BID PACKAGE 02 – ADDENDUM 01**Date:** January 10, 2020**Re:** Wilma P Mankiller Health Center Expansion**From:** James R Childers Architect, Inc.
45 South 4th Street
Fort Smith, Arkansas 72901

CHANGE NARRATIVE LETTER

TO: MATHEW THOMAS- CHILDERS ARCHITECTS
FROM: STEPHEN EDMONDSON, TREY SMITH, BETSY WELLS– HP ENGINEERING, INC.
DATE: 1/10/2020
PROJECT: WPMHC EXPANSION BID PACKAGE 02 ADDENDUM 01

SHEET NUMBER:
M6.05
MECH CEILING
PLAN LEVEL 02
SECTOR 01

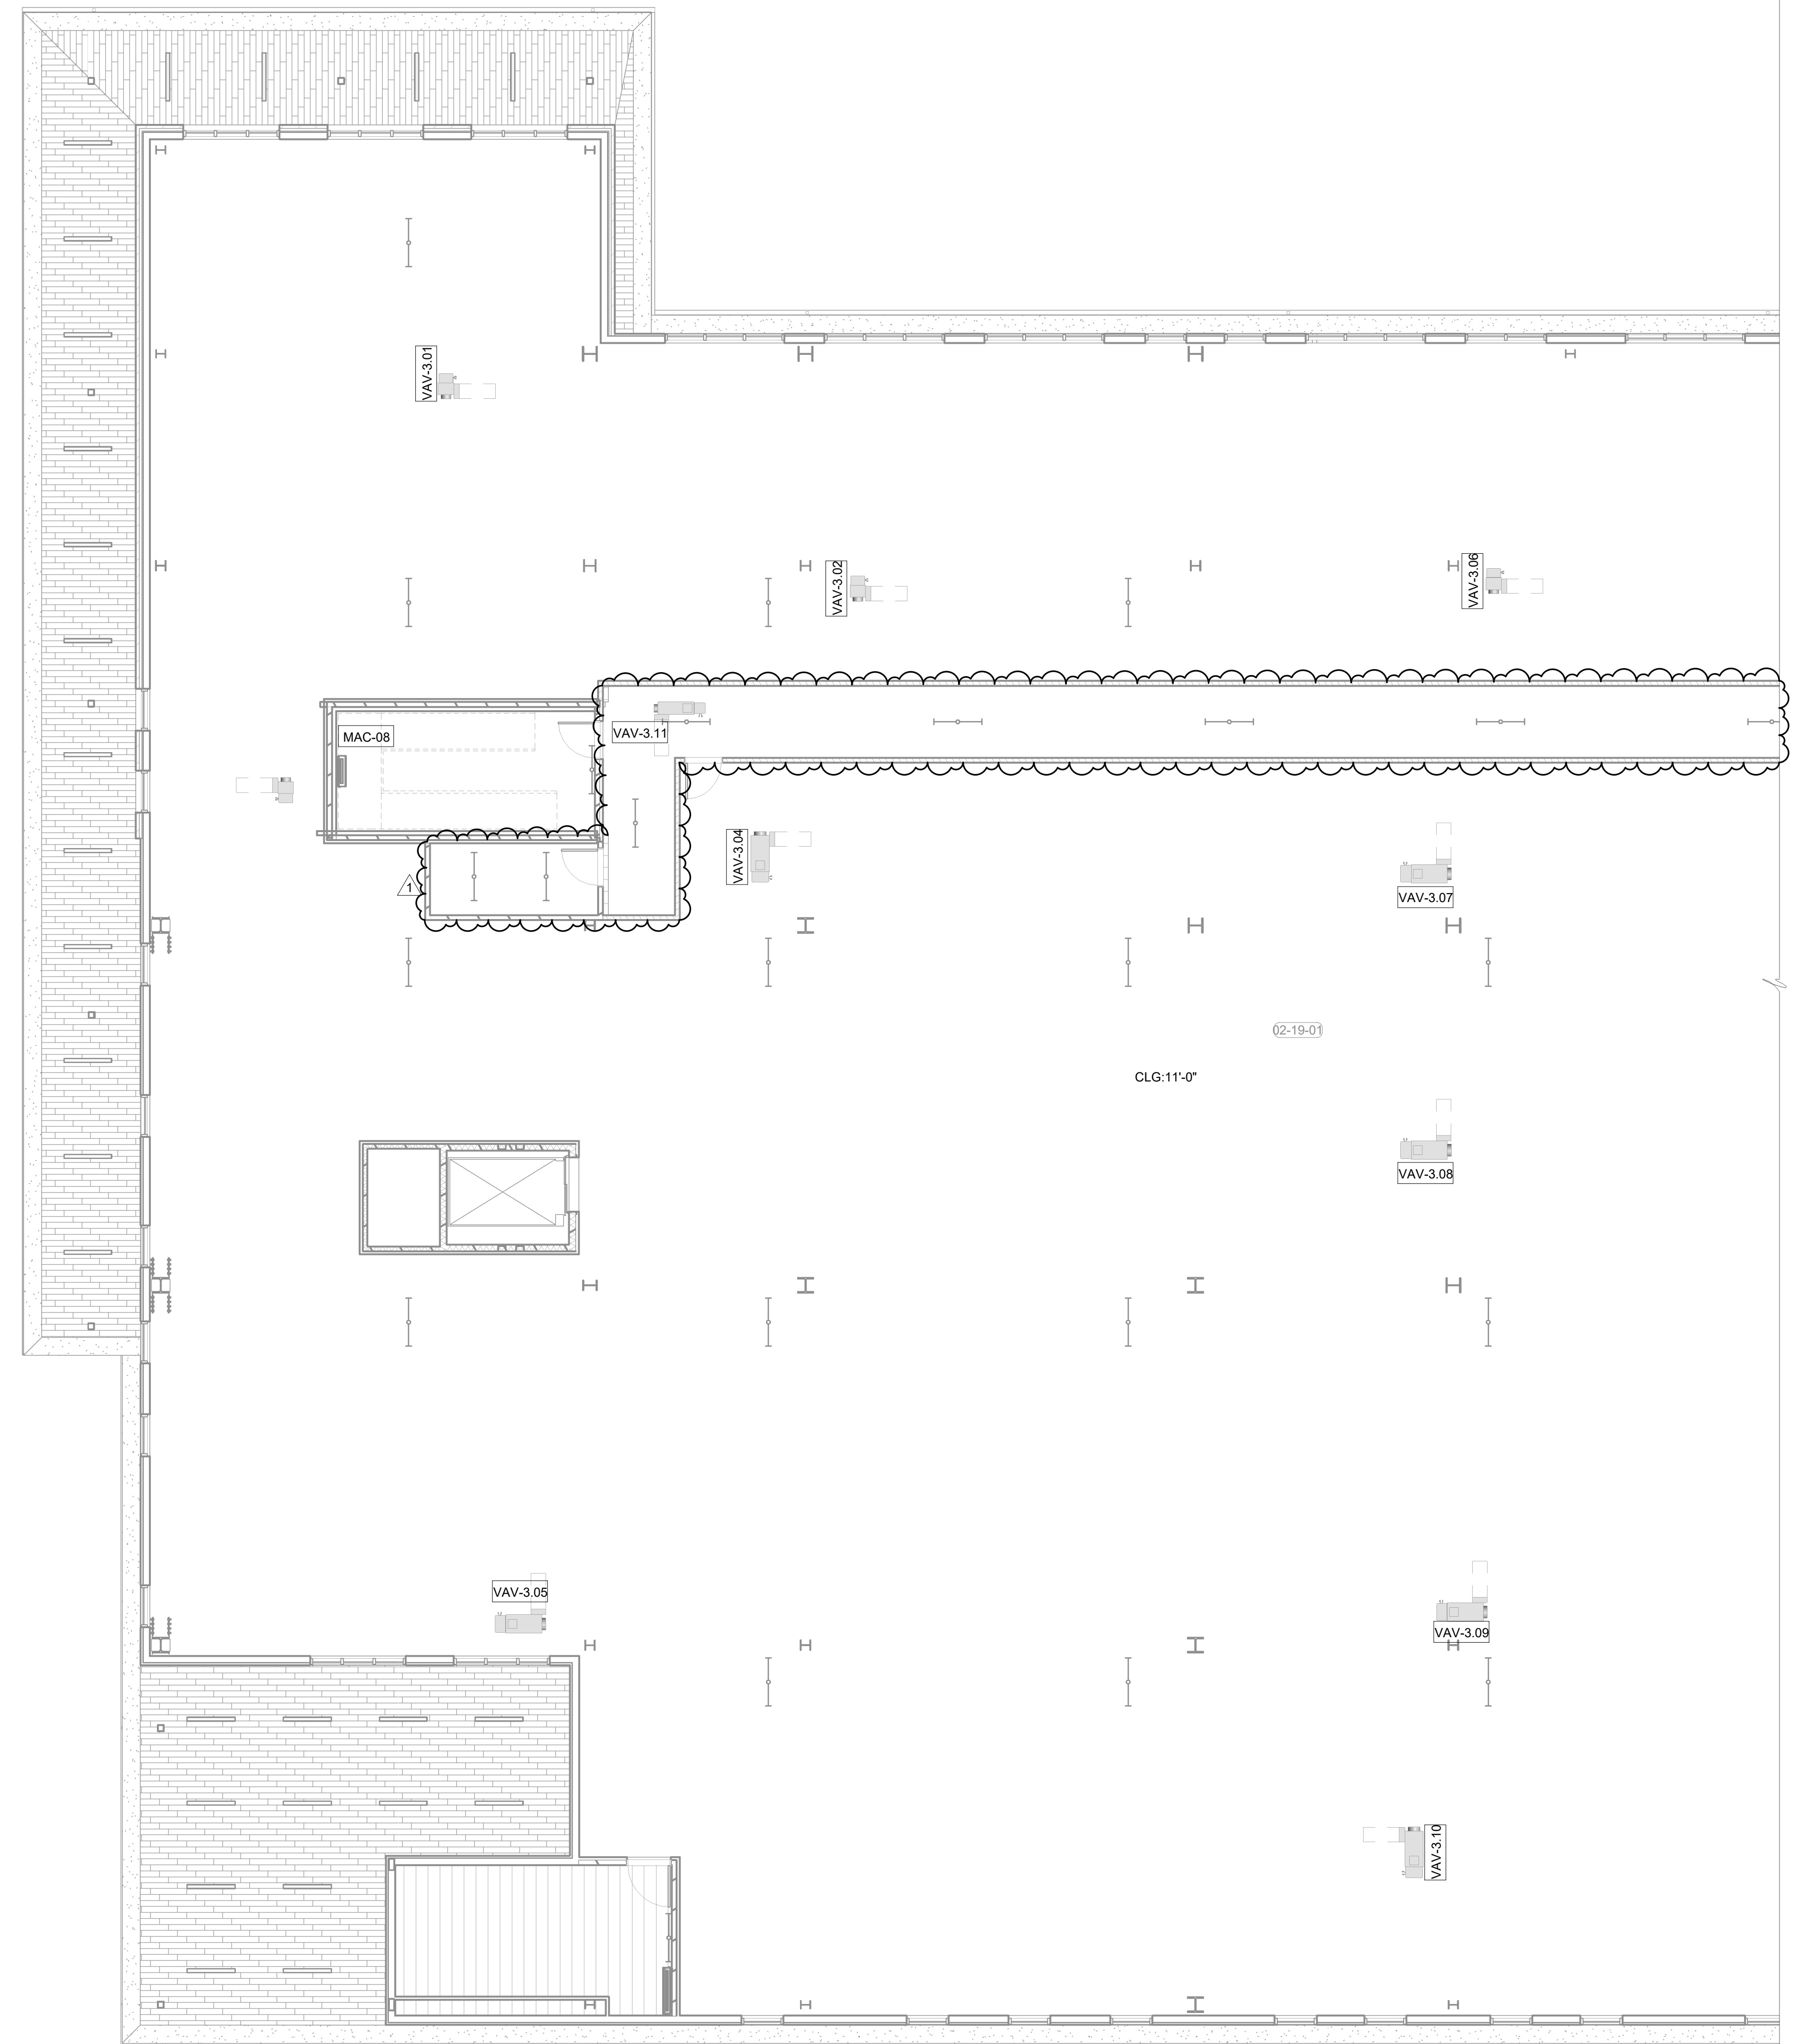
7. M6.04
 - a. Removed air devices from corridor.
8. M6.05
 - a. Removed air devices from corridor.
9. M6.06
 - a. Remove air devices from corridor.
10. M8.01
 - a. Revised hydronic pipe routing to miss electrical equipment.
11. M8.02
 - a. Revised hydronic pipe routing to miss electrical equipment.
12. M8.10
 - a. Added E-stop location for boilers.
13. M8.11
 - a. Added detail callouts for boilers.
